# HARBORD VILLAGE RESIDENTS' ASSOCIATION

December 11, 2011

## Assessment of InfoToGo Pillar Design Modification vs. Vibrant Streets Guidelines

**Attachment 1: Spot the difference...Megabin vs InfoToGo Pillar...**

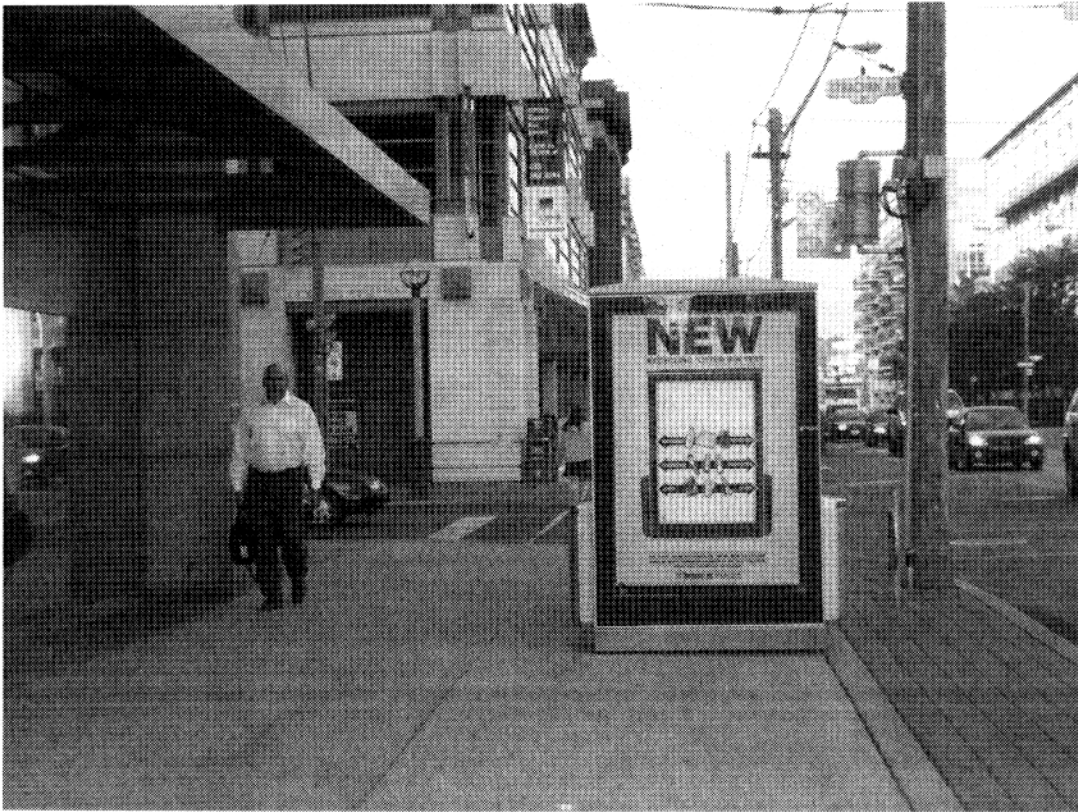
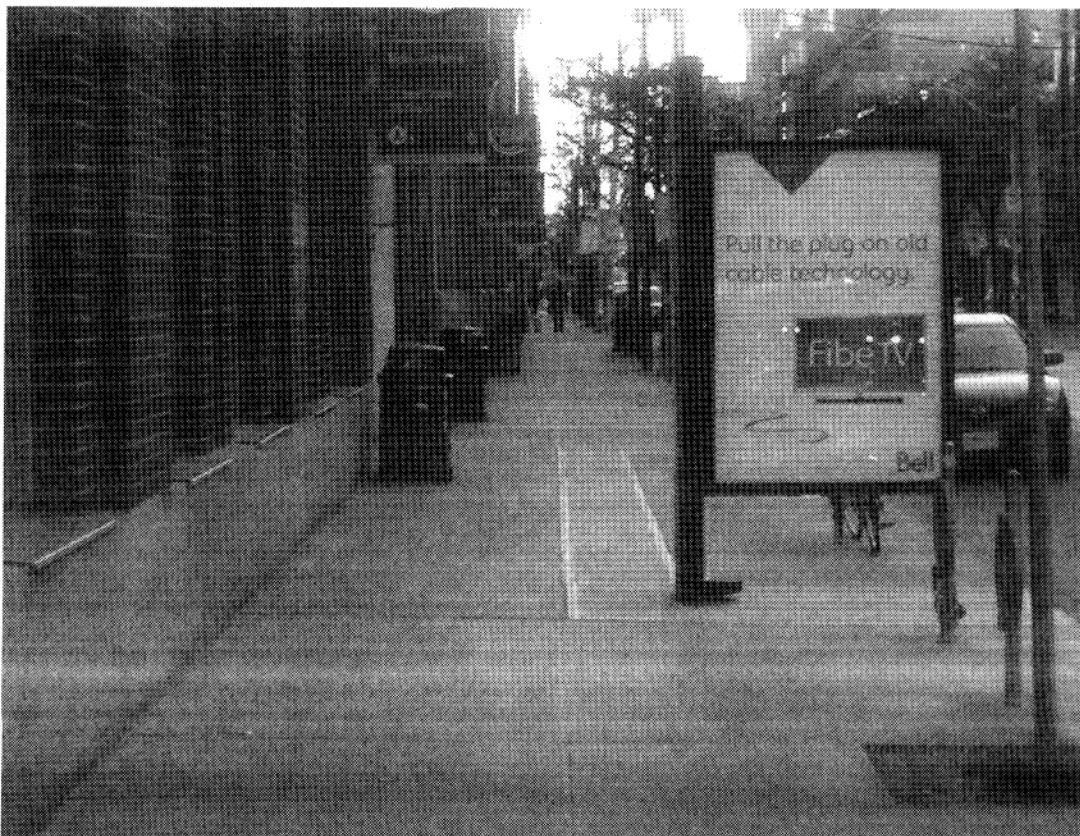
- ✓ VSG (P43) presents a summary of the extensive public consultation process associated with the coordinated street furniture program, and development of Vibrant Street Guidelines. Key Themes and Recommendations (Item 1) states: Workshop participants, those that e-mailed the City and those that filled out questionnaires expressed very clearly that the design and functionality of all street furniture items must be primary: expressing the opinion that Megabins are advertising vehicles rather than functional recycling bins. "They are opposed to them, and any other item that, in the opinion, functions as a "billboard first and street amenity second".
- X Staff report shows: a modified Megabin, with "way-finding" on the spine vs. garbage/recycling slots.

- ✓ Section 3.13 P24: The design of new street furniture must, first and foremost, demonstrate suitability for its intended uses. The design must be driven by the needs of its users and the public must be instantly able to recognize the functionality of elements. The size and scale should not be unduly modified or enlarged simply to accommodate larger advertising panels. Advertising must be tastefully integrated into the design of street furniture, not visa versa (sic).
- X Staff report shows: enlarged ad panels, with suboptimal way-finding integrated into billboard design.
